**Attachment B: Records of Changes to Final Design Submission
Packages**

North Texas OAPM Design Package

DFW SIDs, HUDAD, HRPER, KATZZ, ALIAN and WSTEX DFW RNAV SIDs

RECORD OF CHANGE

Figure 1. Proposed GREGS STAR and Current GREGS STAR (Figure 1 of PFD)

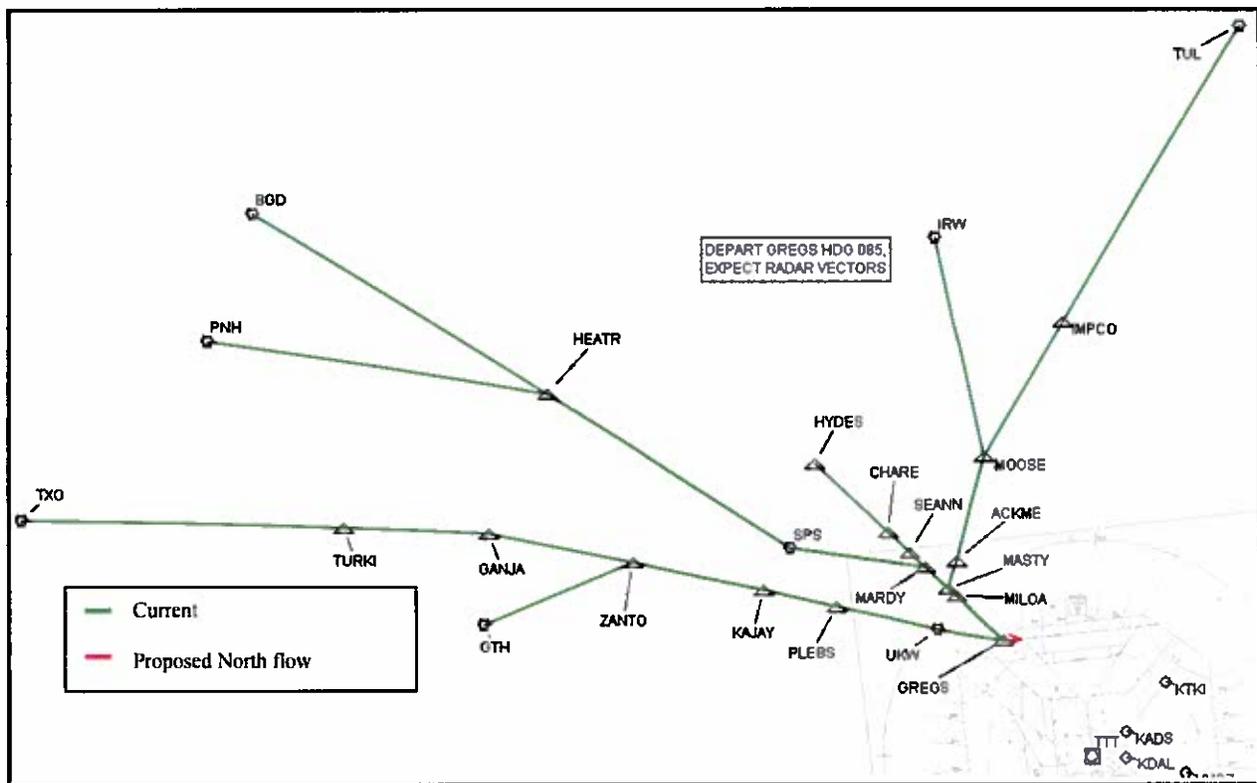
On the GREGS Conventional STAR, in Figure 1 holding patterns were added at MOOSE, ACKME, PLEBS, KAJAY, ZANTO, TURKI and HEATR waypoints, and SPS and UKW VORTACs. These changes are due to incorrect TARGETS files initially used.

Figure 2 below replaced Figure 1 in the PFD.

Figure 2. Proposed WESAT RNAV STAR and MOTZA STAR (Will replace Figure 2 of PFD)

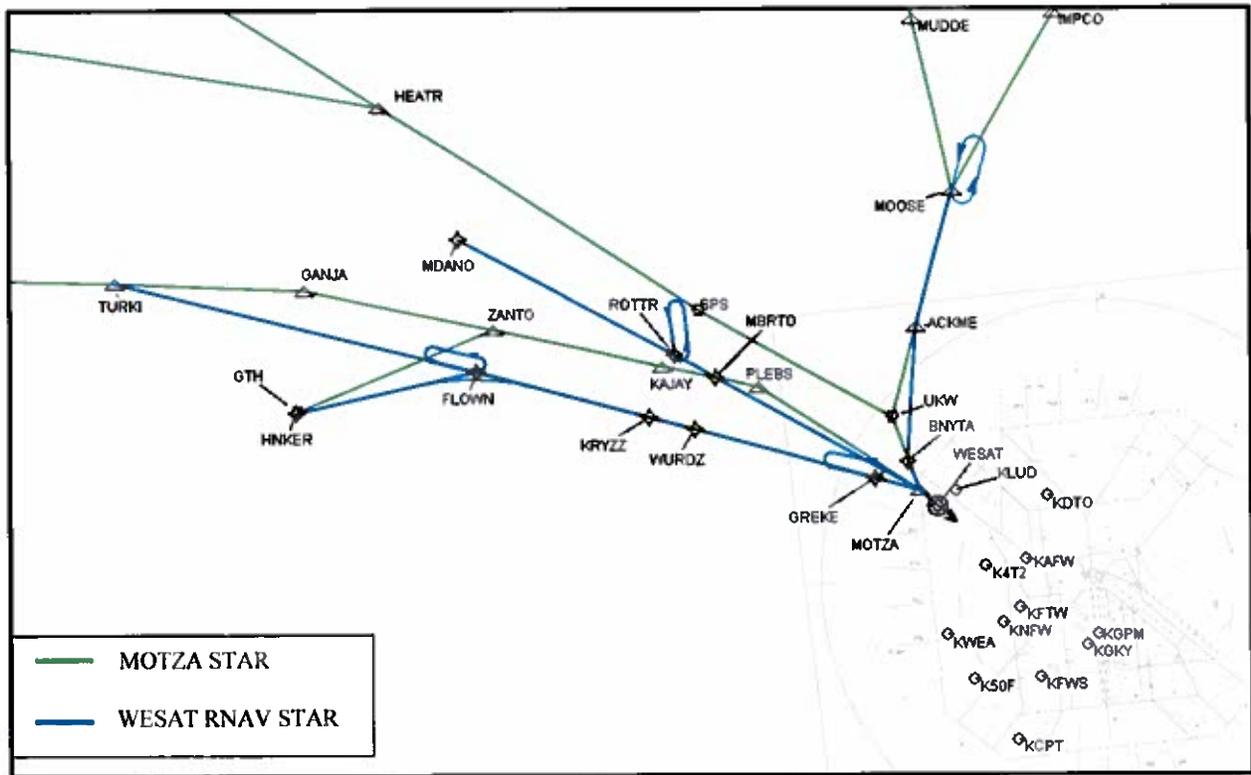
On the WESAT RNAV STAR in Figure 2 a holding pattern was added to MOOSE waypoint.

This change is due to errors on the TARGETS files initially used.

Figure 2 below replaced Figure 2 in the PFD.

Figure 2. Proposed SWVAY RNAV STAR and KNEAD STAR (Will replace Figure 2 of PFD)

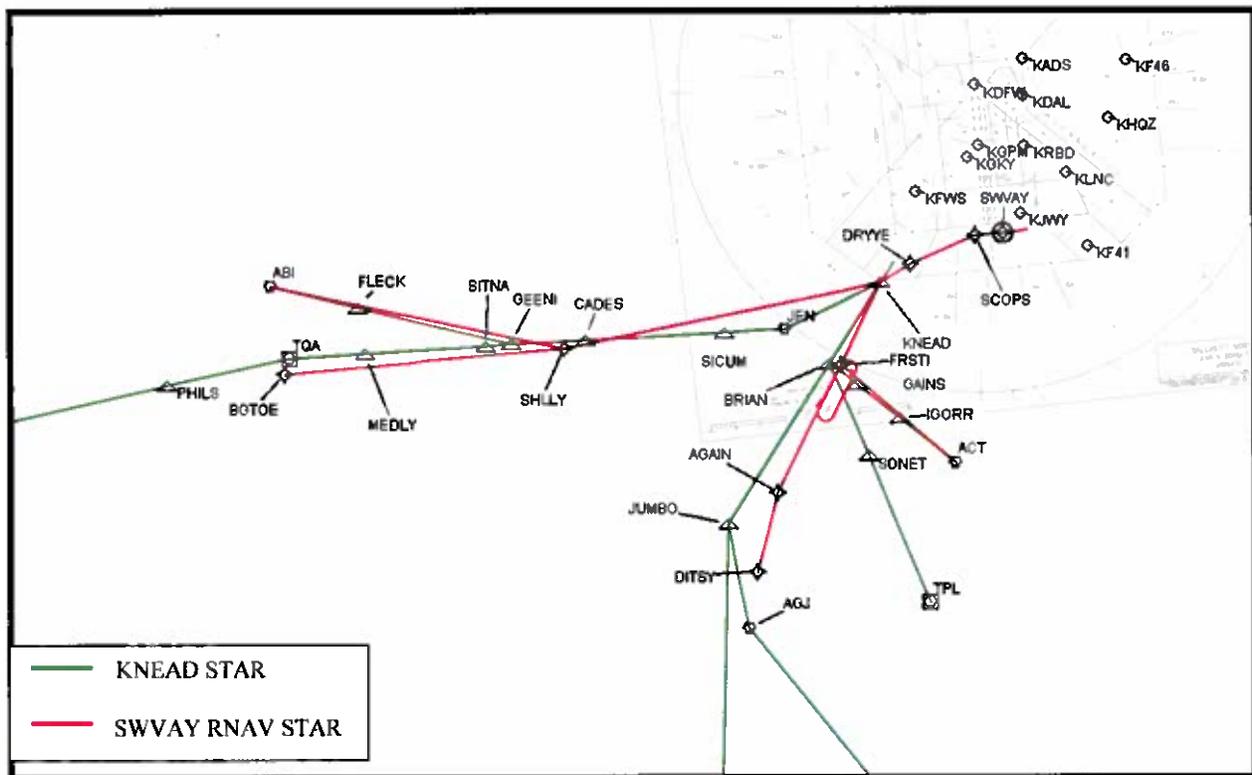
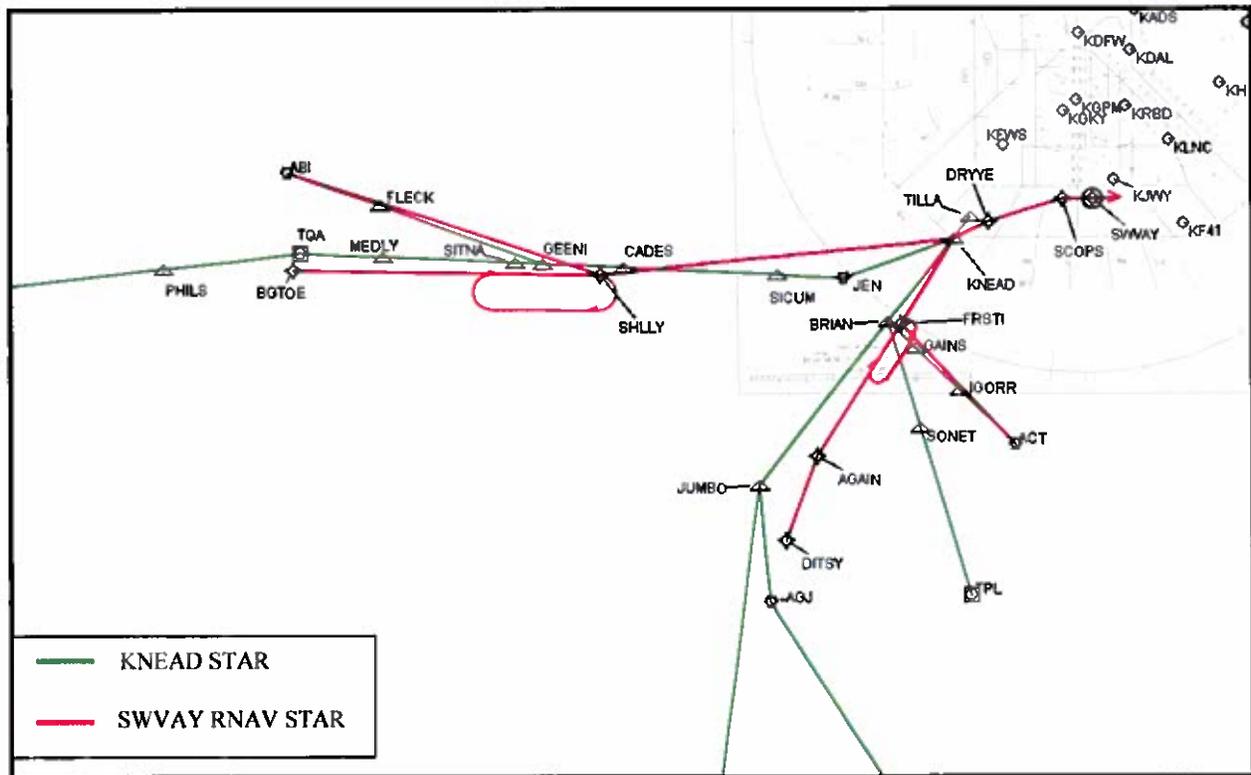
On the SWVAY RNAV STAR in Figure 2 a holding pattern was added to SHLLY waypoint.

This change is due to errors on the TARGETS files initially used.

Figure 2 below replaced Figure 2 in the PFD.

Figure 2. Proposed MNND0 RNAV STAR and DUMPY STAR (Will replace Figure 3 of FD)

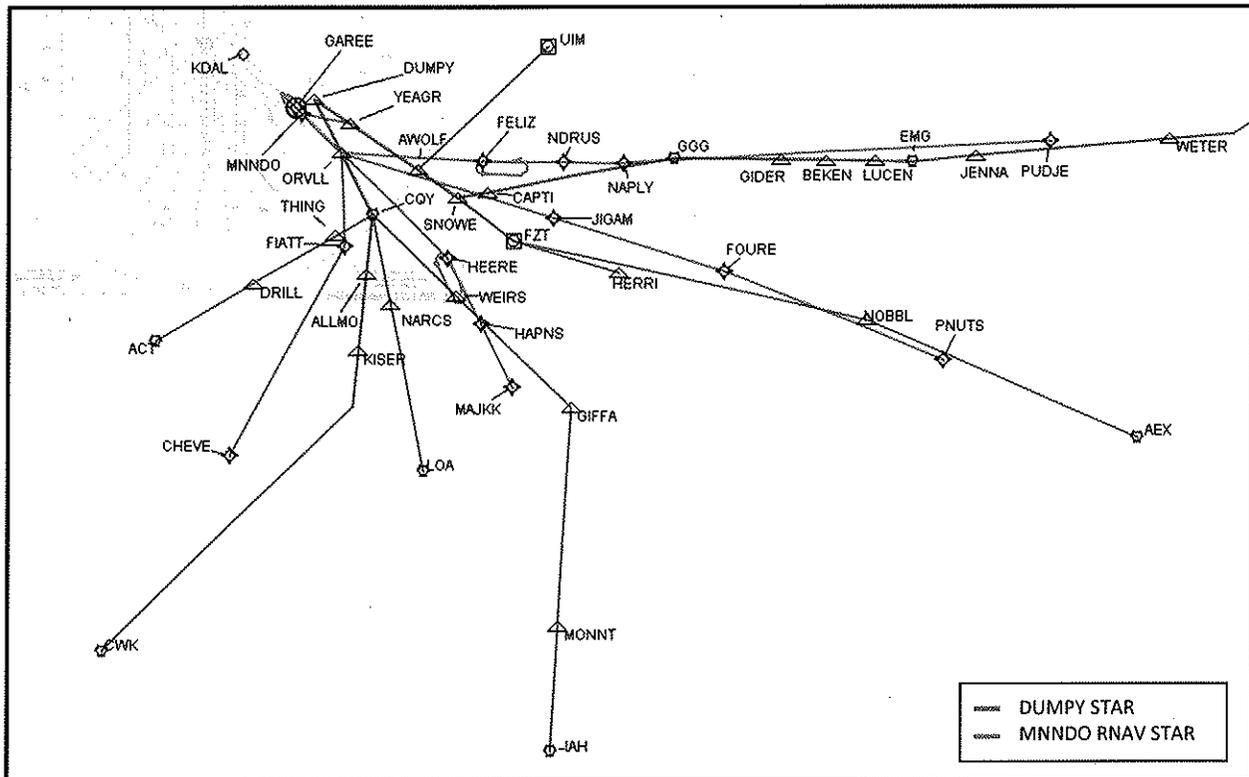
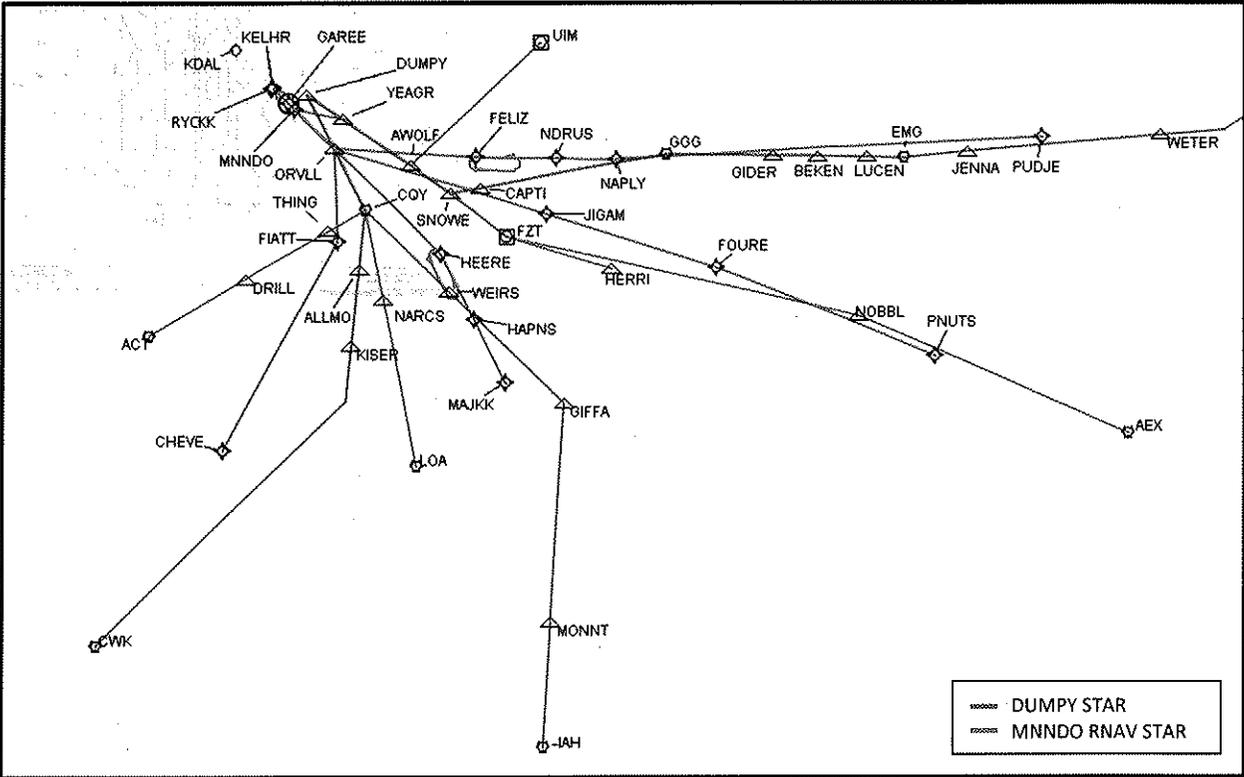
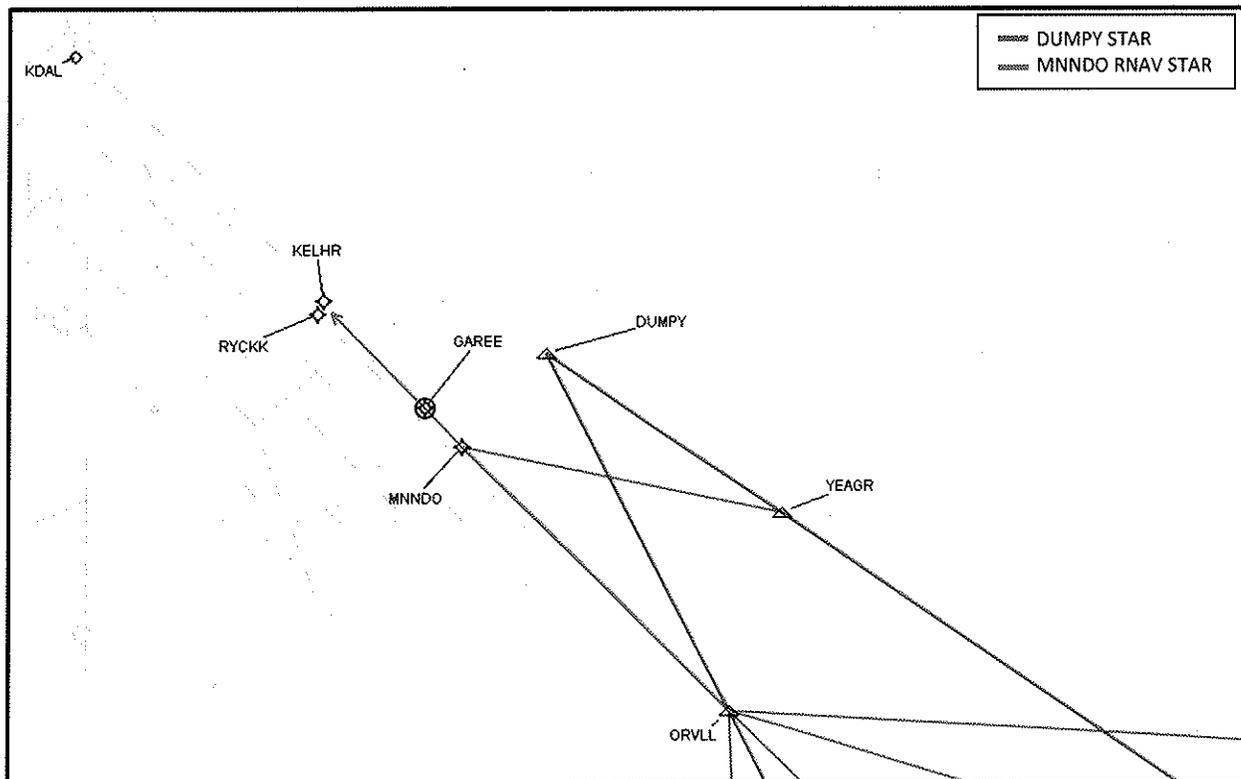
Due to an oversight on Change 2 for the MNND0 RNAV STAR, RYCKK and KELHR waypoints were not depicted on the graphical figure of the procedure. These two waypoints are not part of the actual procedure, but will be included on the chart to allow Dallas-Fort Worth TRACON (D10) operational flexibility when clearing aircraft for the RNP-AR approaches to Runways 31L and 31R at Dallas Love Field.

Figure 2 below replaced Figure 3 in the FD. Figure 3 below was added to the FD as Figure 4 to show detail of the RNAV STAR inside Terminal airspace.

Figure 1. Proposed WILBR STAR and Current WILBR STAR (Figure 1 of PFD)

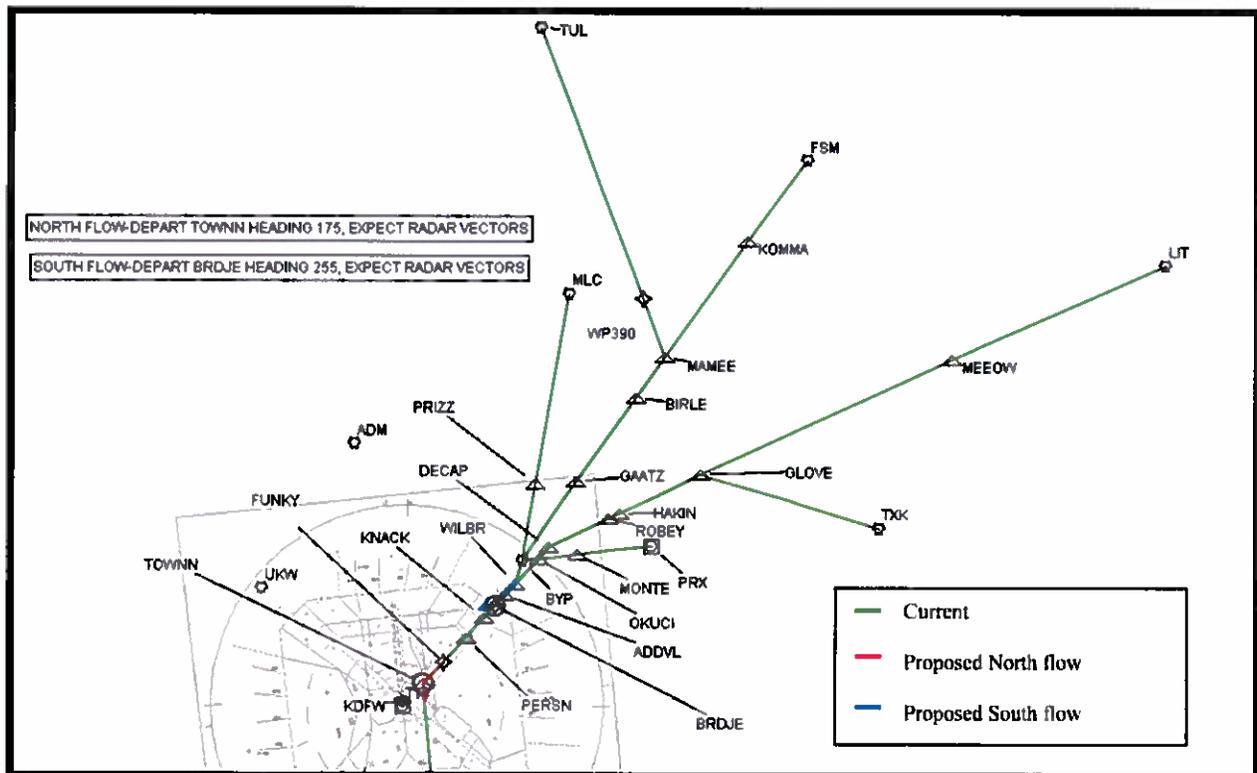
On the WILBR Conventional STAR, in Figure 1 holding patterns were added at GLOVE, HAKIN, GAATZ and BIRLE waypoints. These changes are due to incorrect TARGETS files initially used.

Figure 2 below replaced Figure 1 in the PFD.

Figure 2. Proposed YEAGR STAR and DUMPY STAR (Will replace Figure 1 of PFD)

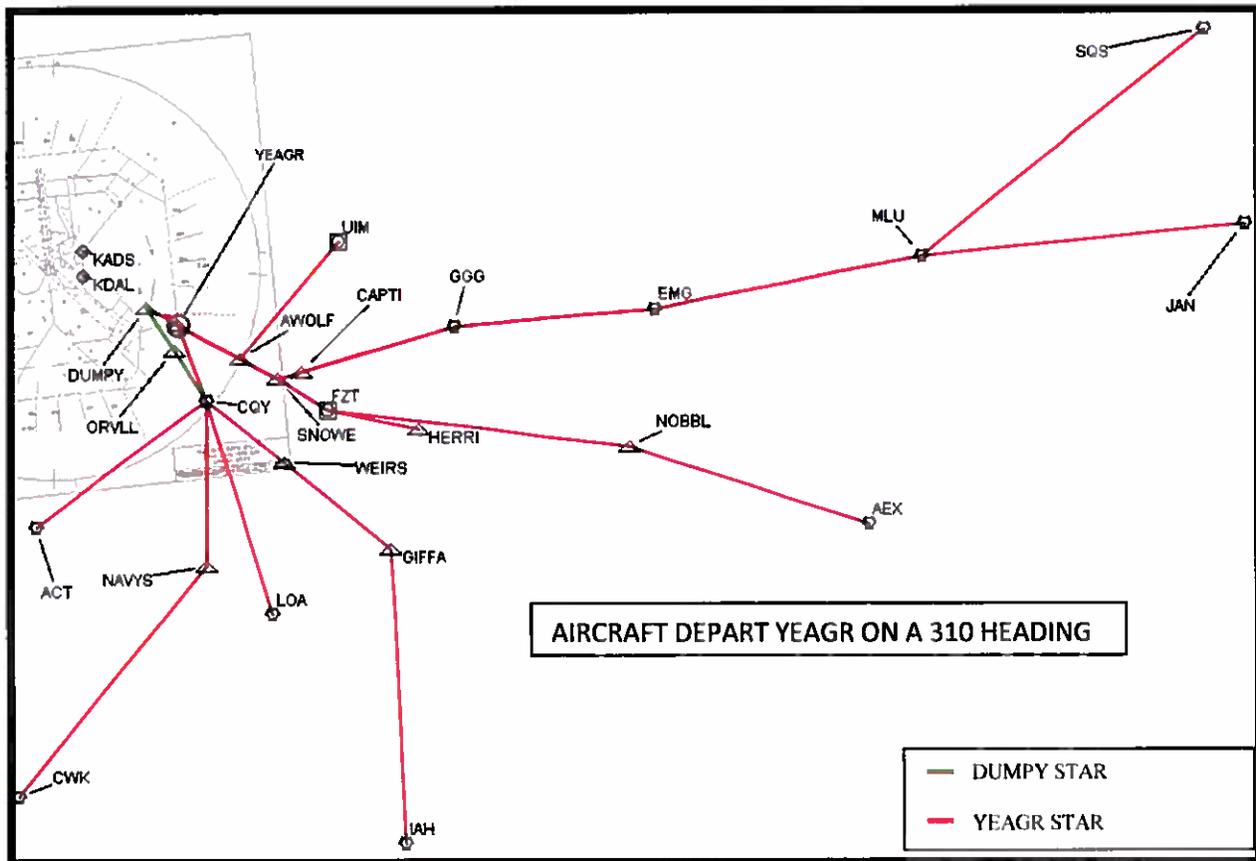
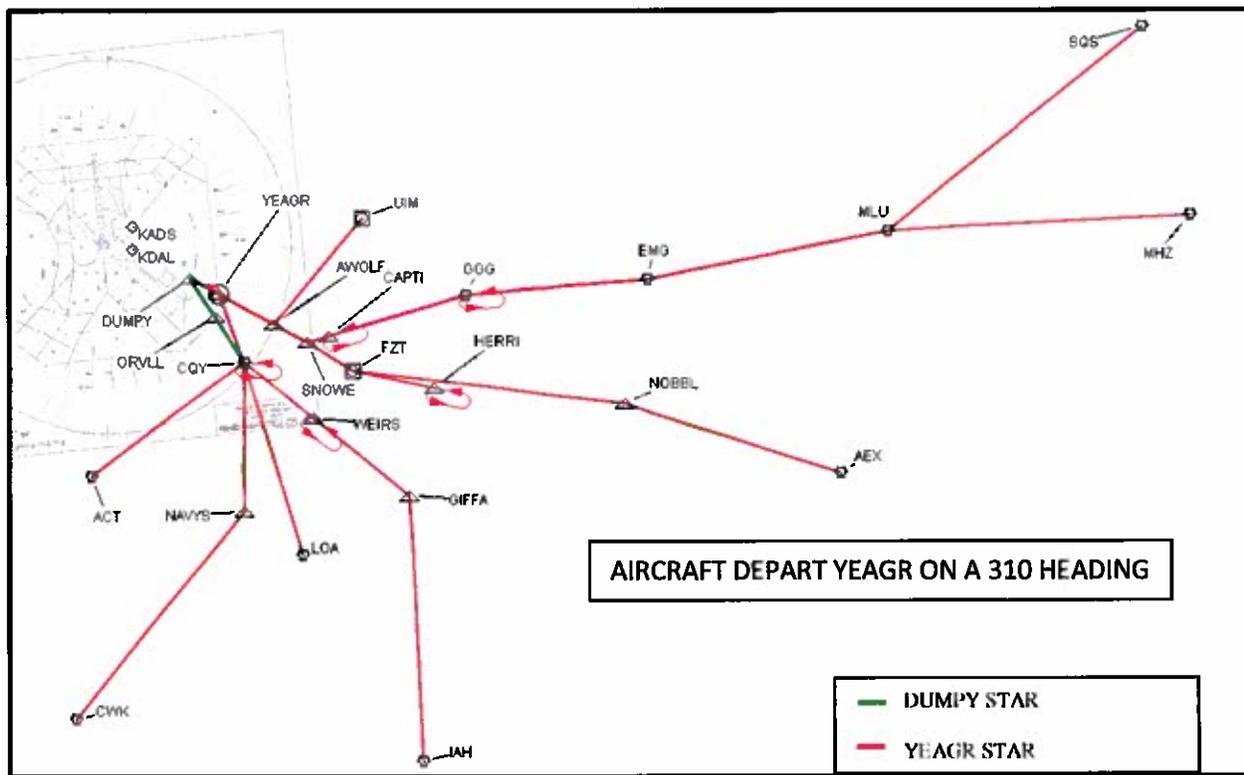
On the YEAGR Conventional STAR, in Figure 1 holding patterns were added at HERRI, CAPTI and WEIRS waypoints, and GGG and CQY VORTACs. These changes are due to incorrect TARGETS files initially used. The JAN VORTAC has been renamed the MHZ VORTAC due to the NAVAID being relocated.

Figure 2 below replaced Figure 1 in the PFD.
